Request for Additional Information No. 195 (2259), Revision 0

03/24/2009

U. S. EPR Standard Design Certification

SRP Section: 04.02 - Fuel System Design

Figure 04.02-10-1—Flex Plug Upper Connection

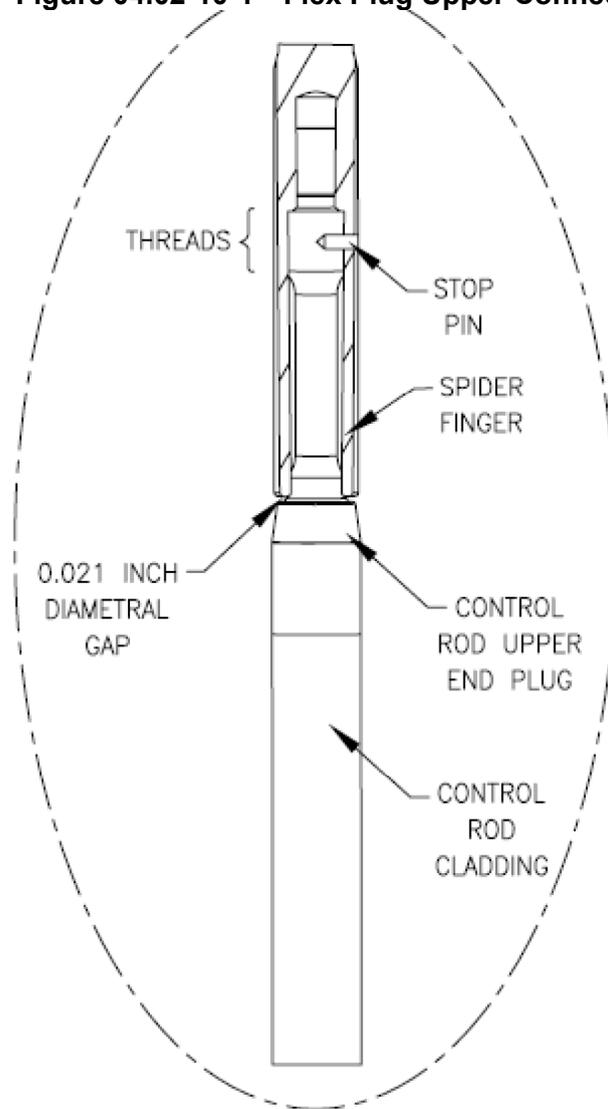
Provide the following additional information on the control rod flex joint:

- a. Description and drawings, explaining the flex joint connection to the RCCA spider, the flex joint material, and how it functions to accommodate misalignment of the RCCA control rod with the fuel assembly guide tubes.
- b. Discuss the operational experience with the control rod flex joint design feature, including any failures of the flex joint.

The upper end plug (UEP), is machined with a reduced diameter shank ($0.180" \pm 0.002"$) and lower shoulder ($0.260" \pm 0.001"$) to provide lateral clearance with the interior diameter of the spider finger (see Figure 04.02-10-1). The clearance allows for elastic deflection of each individual UEP for any misaligned control rod, fuel assembly, upper internals, or fuel handling equipment. The UEP threads into the cavity of the spider finger, with a nominal diametral gap of $0.021"$ between the UEP lower shoulder and spider finger inner diameter. This clearance and the reduced shank diameter allows for elastic lateral deflection of the UEP, while maintaining stresses within design limits.

The UEP is threaded into the spider finger to a specified torque. The threaded connection (finger and UEP) is then drilled (normal to the thread axis) to accommodate a $0.094"$ diameter 308L stainless steel lock pin. The exposed end of the pin is tack welded to the finger.

The threaded and pinned UEP connection design has been used in the U.S. at thirteen plants with no reports of any degradation or failures. The rod cluster control assemblies supplied in the U.S. have used a stainless steel casting spider in lieu of the brazed spider design of the U.S. EPR. However, the method of pinning the UEP-to-spider attachment is similar for both spider designs.
